Service Letter: No. 350

Subject: Alternate compressor drive belt installation for the Bell 412 air conditioner system.

Applicability: Bell Helicopter Model 412 CF, Serial Numbers 46400, 46402, 46404, 46406, 46416, 46418, 46428, 46431, 46443, 46447, 46451, & 46475.

Reference: F.A.A./ S.T.C. # SR00066DE, Bell 412 Air Conditioner System Dwg. 412AC-304

View looking inboard from aircraft left, Bell 412 CF

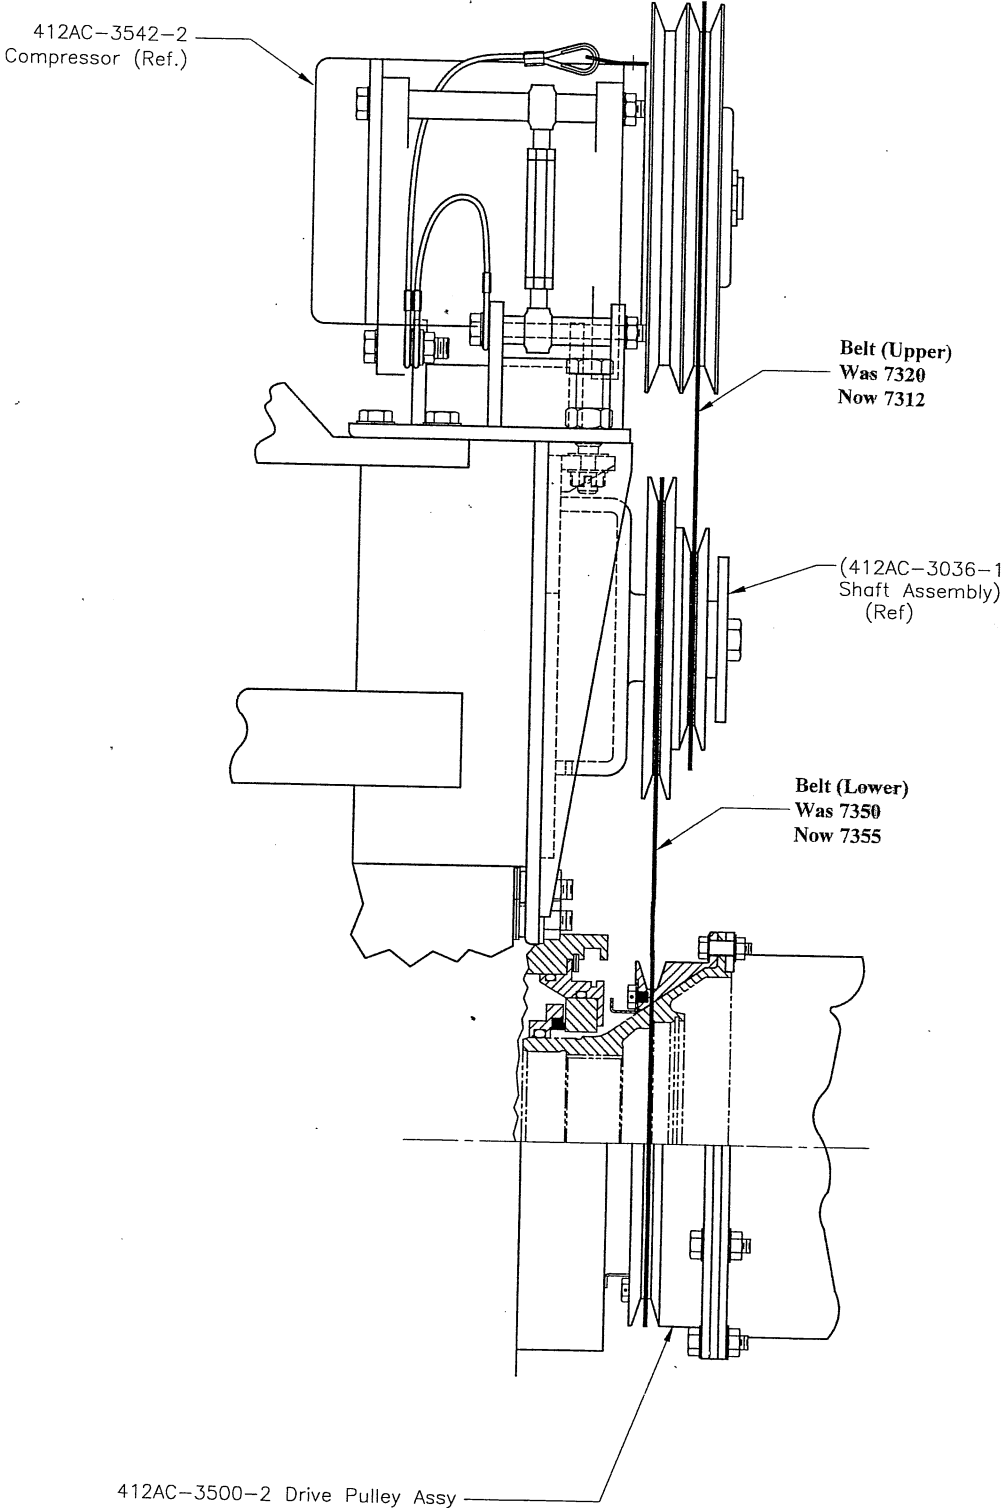
Discussion: This alternate compressor drive belt configuration is to allow for the ease of installation and adjustment of the air conditioner drive belts on the Bell Helicopter Model 412 CF only.

Parts to be removed

Item	Part Number	Description	Quantity
1	7320	Belt	1
2	7350	Belt	1

Parts to be installed

Item	Part Number	Description	Quantity
1	7312	Belt	1
2	7355	Belt	1
